Project	IEEE 802.16 Broadband Wireless Access Working Group < http://ieee802.org/16 >	
Title	Inheritance Relationship of 802.16 Mobility MIB	
Date Submitted	2006-03-07	
Source(s)	Yanbiao Chen Ling Xu Shuangqiang Huang ZTE corporation	xu.ling@zte.com.cn
	Danling Gong CATR	gongdaning@catr.com.cn
Re:	Contribution to IEEE 802.16i	
Abstract	In this contribution, we propose to provide inheritance relationship of 802.16 mobility MIB	
Purpose	Adoption	
Notice	This document has been prepared to assist IEEE 802.16. It is offered as a basis for discussion and is not binding on the contributing individual(s) or organization(s). The material in this document is subject to change in form and content after further study. The contributor(s) reserve(s) the right to add, amend or withdraw material contained herein.	
Release	The contributor grants a free, irrevocable license to the IEEE to incorporate text contained in this contribution, and any modifications thereof, in the creation of an IEEE Standards publication; to copyright in the IEEE's name any IEEE Standards publication even though it may include portions of this contribution; and at the IEEE's sole discretion to permit others to reproduce i

Figure 13 IEEE802.16 NRM PacketCS Inheritance Diagram

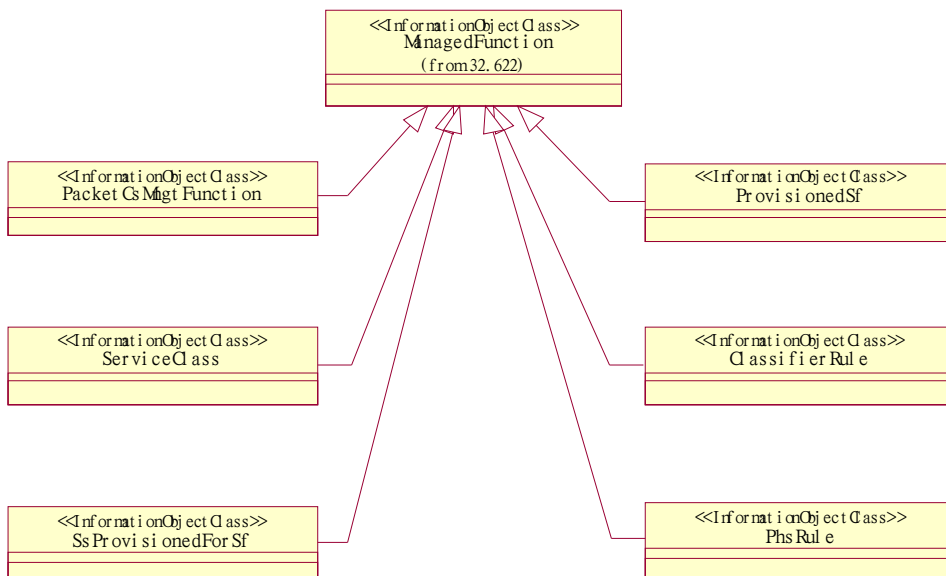
[Add the following description into 16i 15.1.2.2.2:]

The PacketCS IOC inheritance hierarchy:

Figure 14 IEEE802.16 NRM CPS Inheritance Diagram

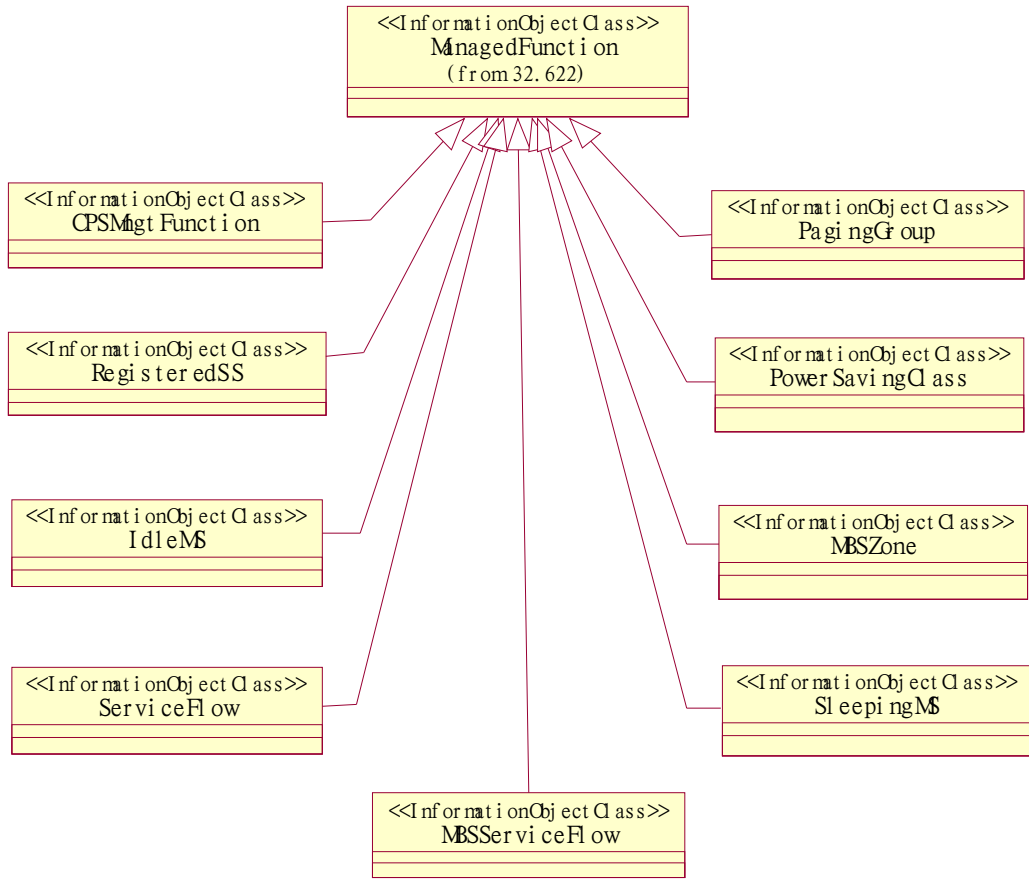
The CPS IOC inheritance hierarchy:

Figure 15 IEEE802.16 NRM Security Sublayer Inheritance Diagram

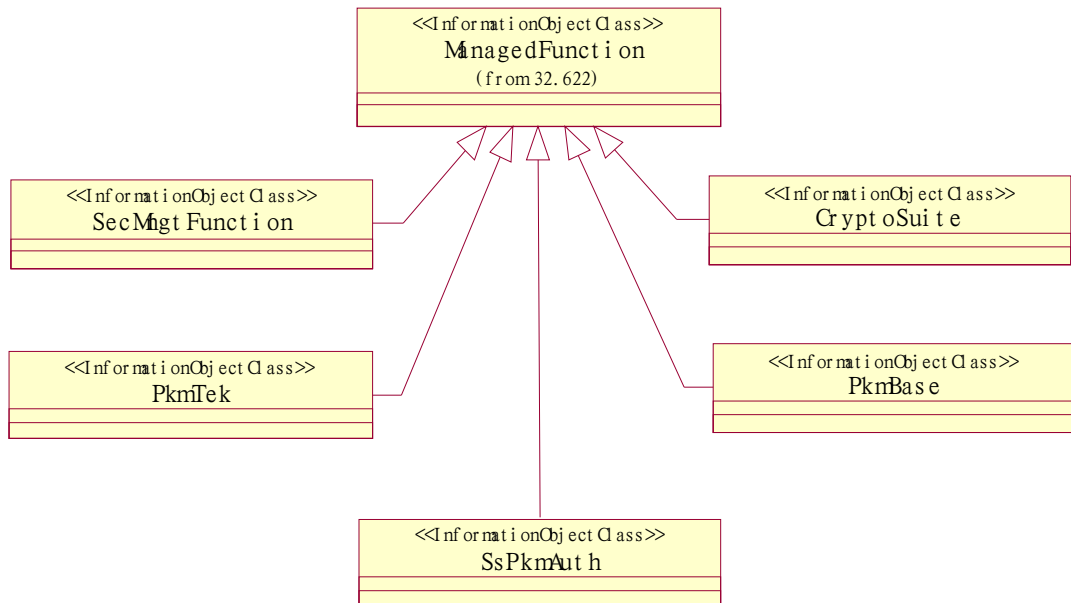
The Security sublayer IOC inheritance hierarchy:

Figure 16 IEEE802.16 NRM PHY Layer Inheritance Diagram

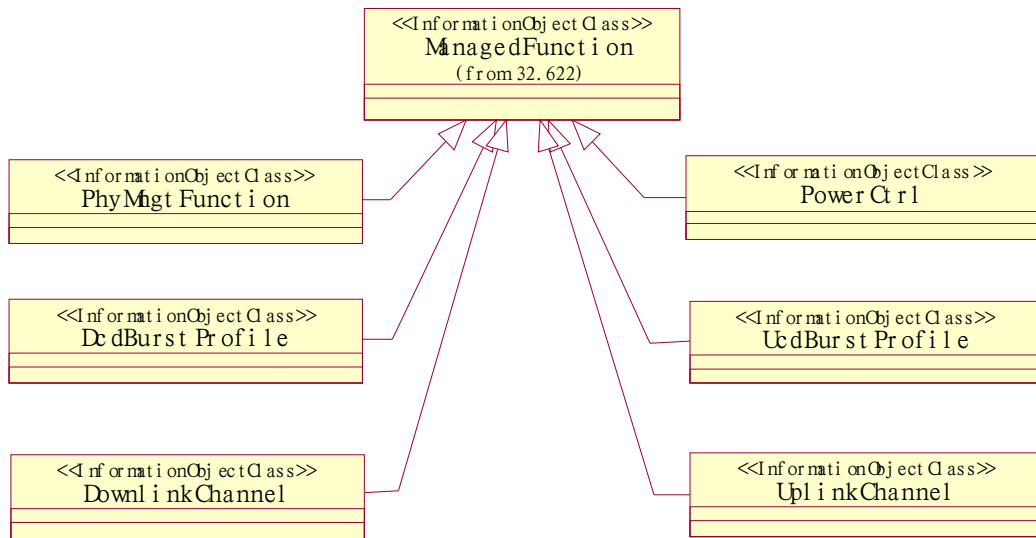
The PHY layer IOC inheritance hierarchy:
